**Comments on  
Climate Action Reserve Nitrogen Management Project Protocol  
Reducing N<sub>2</sub>O Emissions through Improved Nitrogen Management in Crop Production**

Version 1.0 for Public Comment (April 24, 2012)

**May 23, 2012**

**Fig.1. Uncertainty deduction functions: a) original step-wise CDM reduction function (dashed), b) NMPP quadratic reduction function (solid blue), c)  $\exp^{(\text{Unc}/330)}$  (brown), d)  $1 - 2.3 \times 10^{-3} \text{ Unc}$  (orange).**

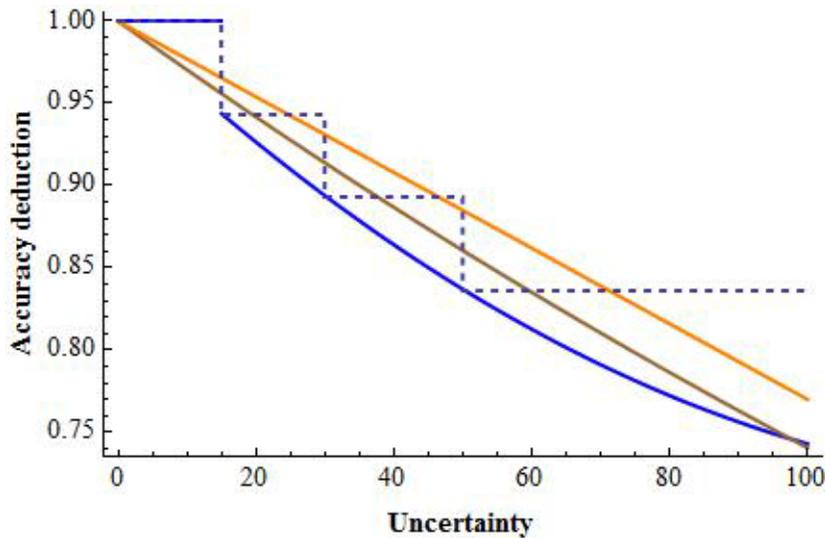
- d. Currently, the accuracy deduction equation is:

$$\mu_{struct,f} = 138 \times 10^{-7} \times UNC_{PER,f}^2 - 395 \times 10^{-5} \times UNC_{PER,f} + 0.999$$

While this quadratic function (Fig 1 b, below) is a conservative approximation of the step-wise function (Fig 1 a below) it is not the simplest approximation of the original step-wise function.

e. **Recommendation:** Use either (i) or (ii) below; preferably (i):

i.  $\mu_{\text{struct},f} = (\exp^{(\text{Unc} / 330)})$

a simple function with a small deviation (maximum of ~2 %) from the more complex quadratic function (Fig 1 c).

ii.  $\mu_{\text{struct},f} = (1 - 2.3 \times 10^{-3} \text{ Unc})$

a linear function, that has a slope derived from the integration of uncertainty approach (pdf [File Integration of the Uncertainty] attached), again with a small deviation (maximum of ~ 4%) from the more complex quadratic function (Fig 1 d). The linear approach is the only one that allows us to discard a constant proportion of the emission reductions we are uncertain of, without the need to relate it back to the relative % of total emission reduction it represents.
